City of El Paso – City Plan Commission Staff Report

REVISED

Case No:	SUSU16-00036 Cimarron Canyon Unit One Subdivision
Application Type:	Major Combination
CPC Hearing Date:	June 30, 2016
Staff Planner:	Alfredo Austin, 915-212-1604, *austinaj@elpasotexas.gov*
Location:	East of Resler and North of Northwestern
Acreage:	97.393 Acres
Rep District:	1
Existing Use:	Residential & Commercial
Existing Zoning:	R-3A/c & C-3/c (Residential & Commercial)
Proposed Zoning:	R-3A/c & C-3/c (Residential & Commercial)
Nearest Park:	3 parks proposed within subdivision (4.228 acres)
Nearest School:	Canutillo High School (1.79 miles)
Park Fees Required:	N/A
Impact Fee Area:	West Side Impact Fee Service Area.
Property Owner:	Cimarron Hunt Communities, LLC
Applicant:	Cimarron Hunt Communities, LLC
Representative:	CSA Design Group, Inc.

ATTACHMENT 3

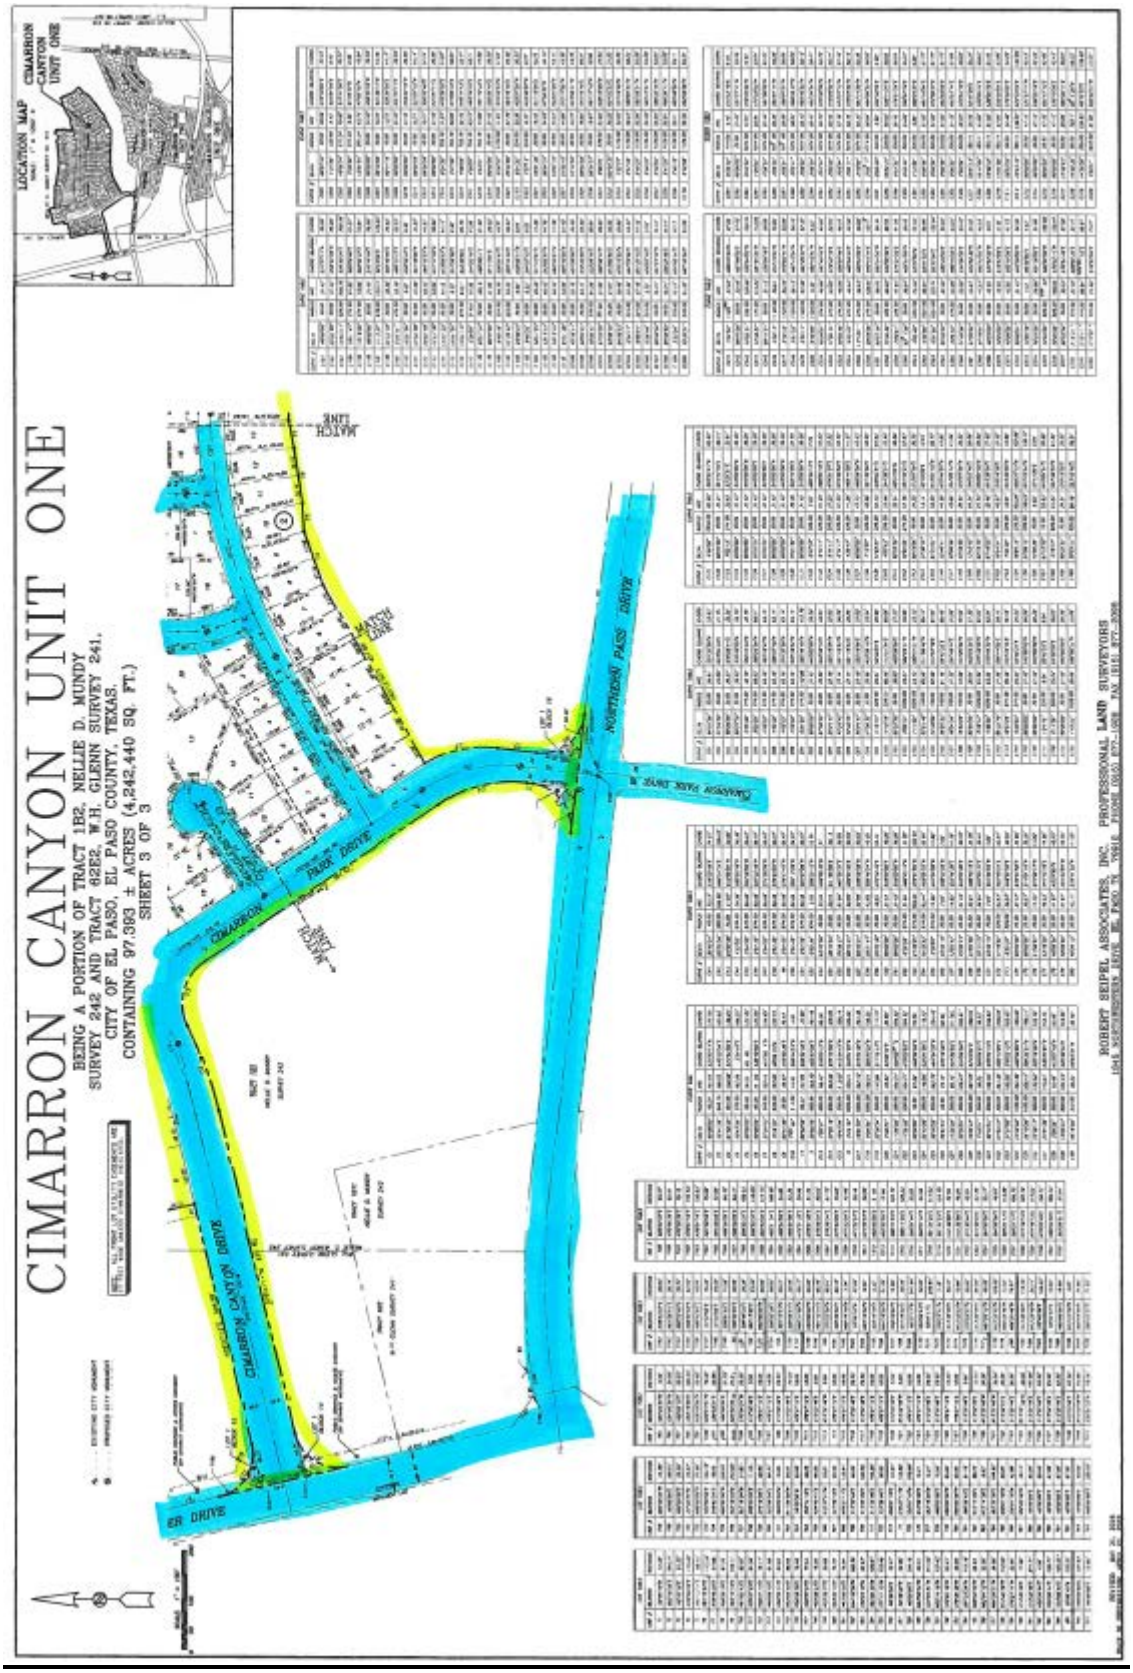
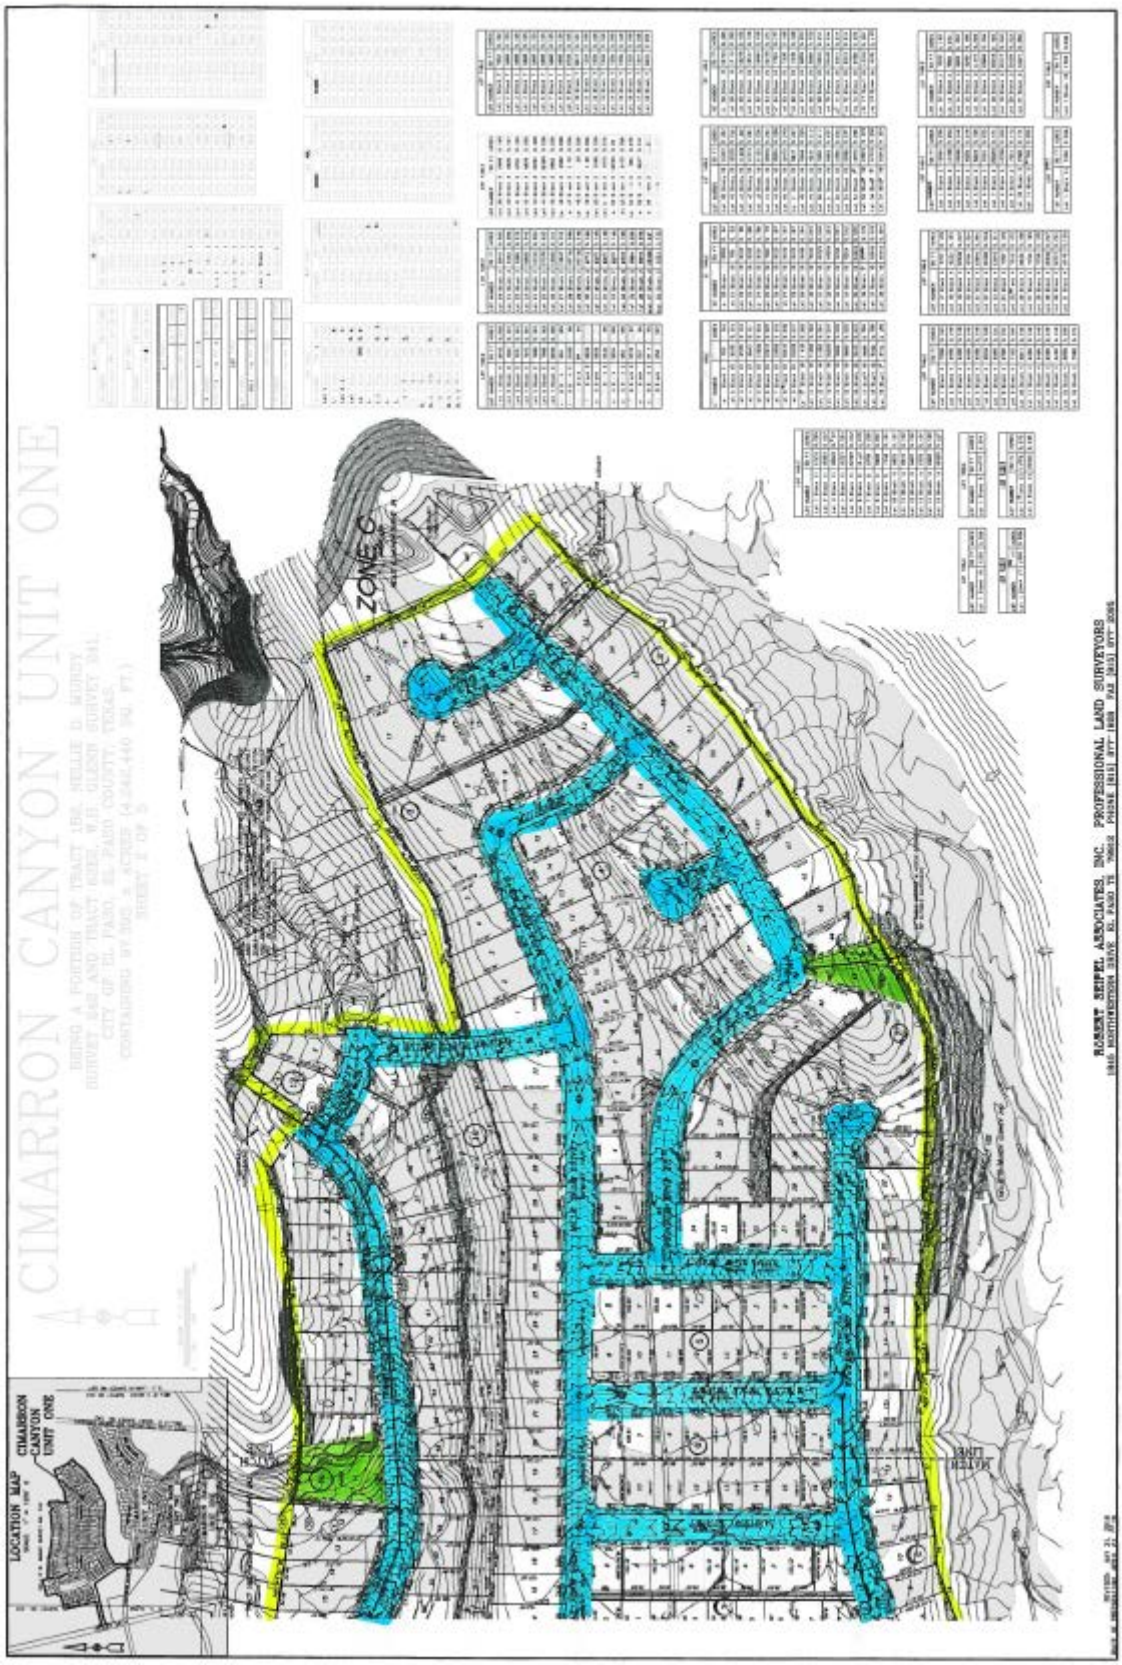
1. No grading shall be allowed outside of the subdivision limits (Chapter 18.44). Proposed grading to make a Retention/Detention Pond or Dam upstream of Bobcat Hollow Drive to serve this subdivision is shown to the N.W. outside of this subdivision boundary lines.
2. Complete drainage infrastructure serving this subdivision must be built within subdivision limits (Chapter 19.08.010).

3. Delineate and dimension proposed pond boundary limits by bearing and distance and label whether it is to be a retention or detention pond and either public or private. Update dedication statement if necessary.

8. At the Improvement Plan stage, the developer shall provide the design and calculations for the Retention/Detention Pond or Dam upstream of Bobcat Hollow Dr., for review and approval. Show entire extents of offsite contributing watershed areas.

9. Some of the drainage easements or ROW's are not identified as "Public" or "Private; please label them accordingly.
10. Show existing contours as dashed lines and leave the proposed as solid lines.
